Docket Number:	15-AFC-01
Project Title:	Puente Power Project
TN #:	211007
Document Title:	Letter Regarding Use of Beta Model in Air Quality Modeling
Description:	Letter
Filer:	Alison Seel
Organization:	Sierra Club
Submitter Role:	Intervenor
Submission Date:	4/12/2016 10:54:41 AM
Docketed Date:	4/12/2016

April 11, 2016

Re: Concerns with Reliance on Unapproved “Beta Option” in Air Quality Modelling for Puente Power Project

Quantile-Quantile Plots for Tracy EGU Evaluation

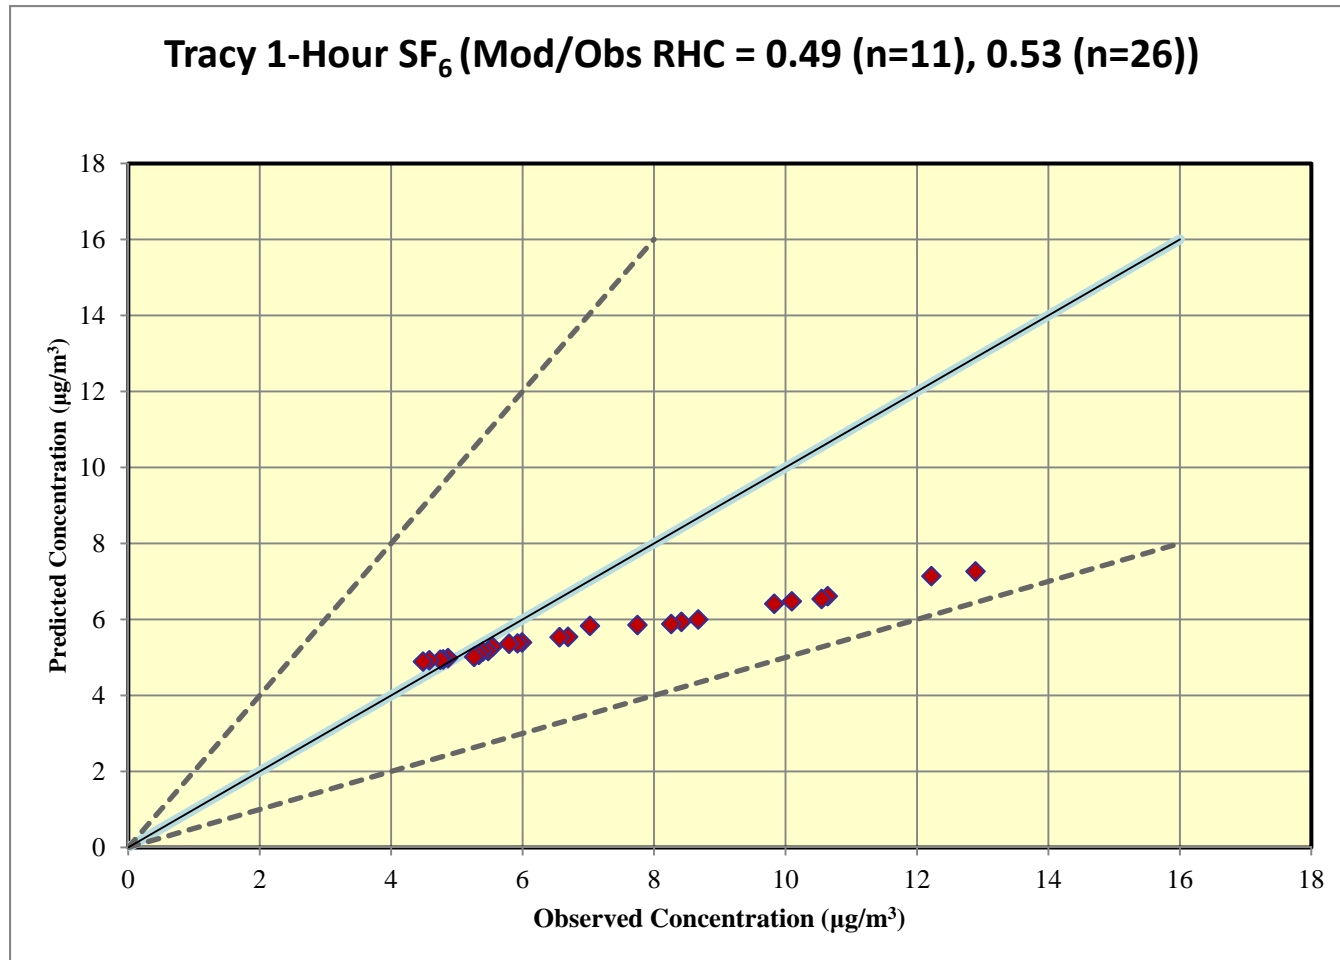
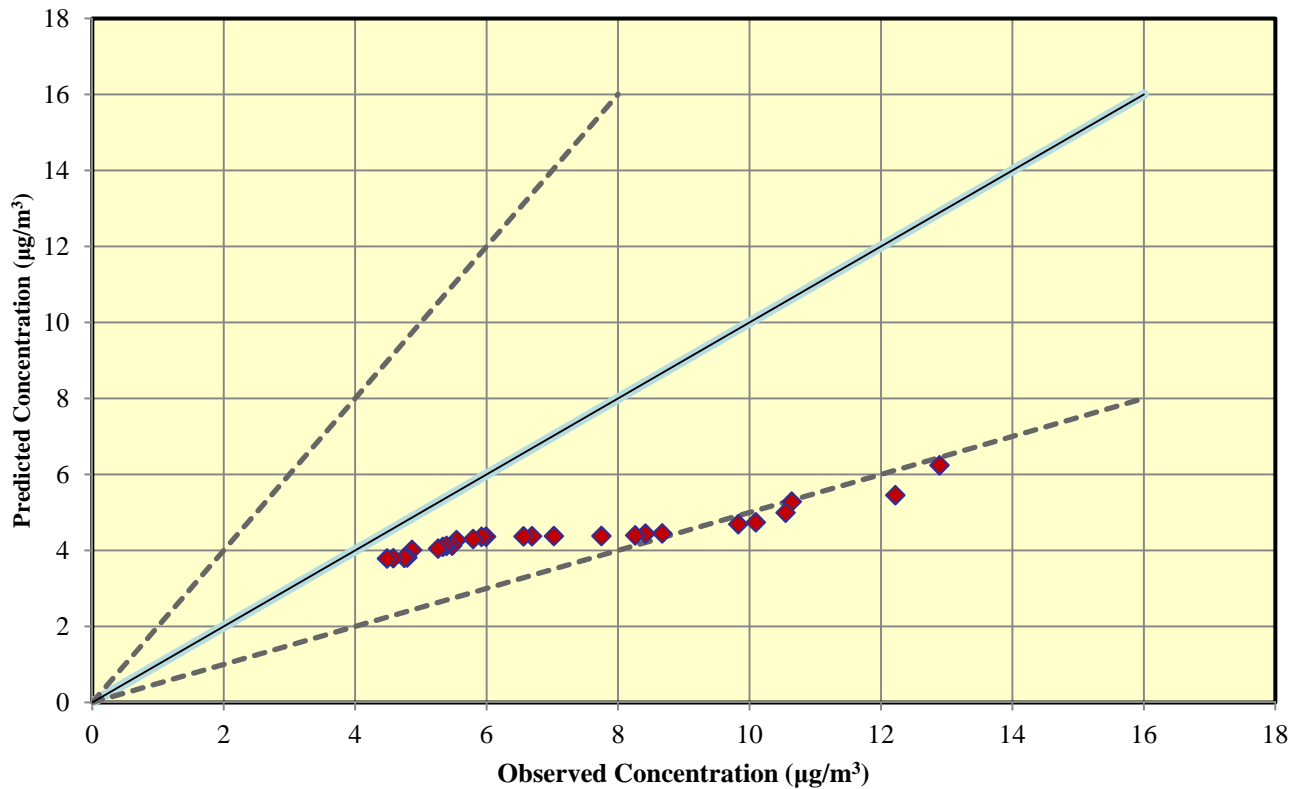
The AERMET ADJ_U* and AERMOD LOWWIND3 options often lead to substantial model under-predictions. For the Tracy power plant evaluation shown above, *these options cause AERMOD results to be less than 50% of the monitored values*. This is a serious concern not addressed by USEPA.
